**SITE INSPECTION REPORT**  
Tank Area LNG Impoundment  
Sump –Base Pour

<b>Project Title:</b>	<b>AGL NGSF</b>	<b>Date:</b>	<b>01/08/2013 3PM</b>
<b>Ref No:</b>	<b>30011141</b>	<b>By:</b>	<b>Brendan Drake</b>
<b>Client:</b>	<b>AGL</b>	<b>Issued To:</b>	<b>Tim Knill</b>
<b>Contact:</b>	<b>Vito DiRenzo (CBI)</b>	<b>Page:</b>	<b>1 of 2</b>

General photo showing installed slab reinforcement and waterstop

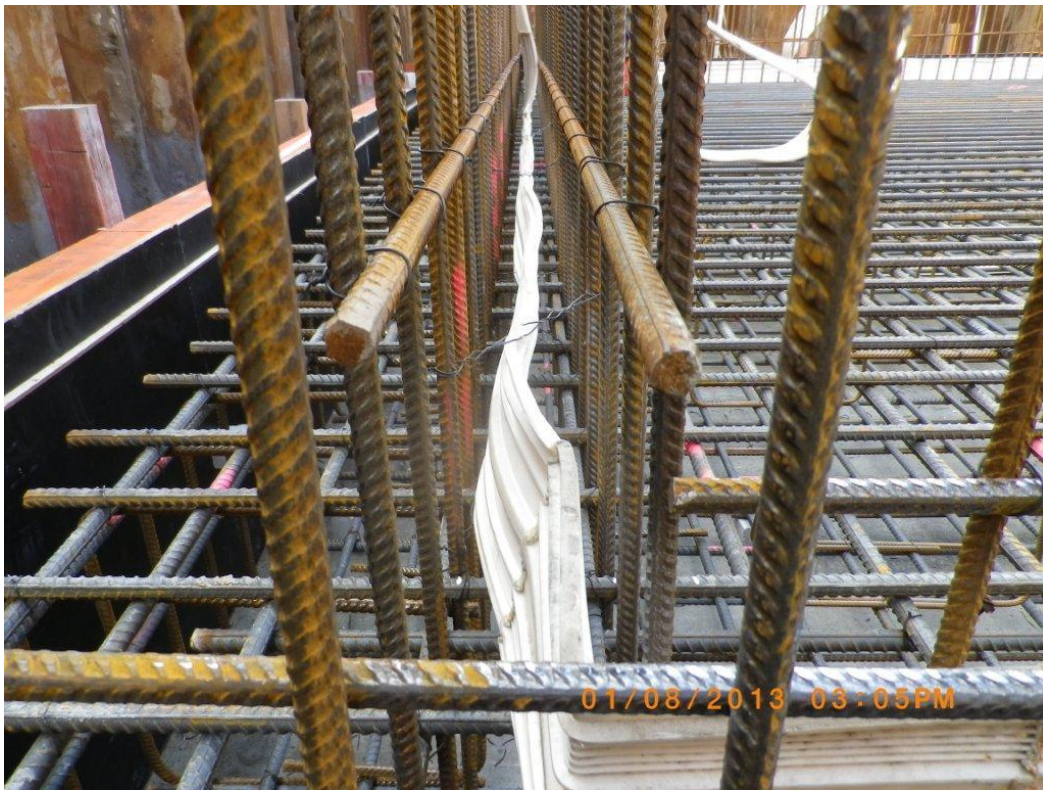
2. Construction appeared to be of a standard that would allow the works to comply with the Approved Storm Water Management Philosophy. In particular SMEC noted water stops placed in position in accordance with the design drawings (refer to photos attached).
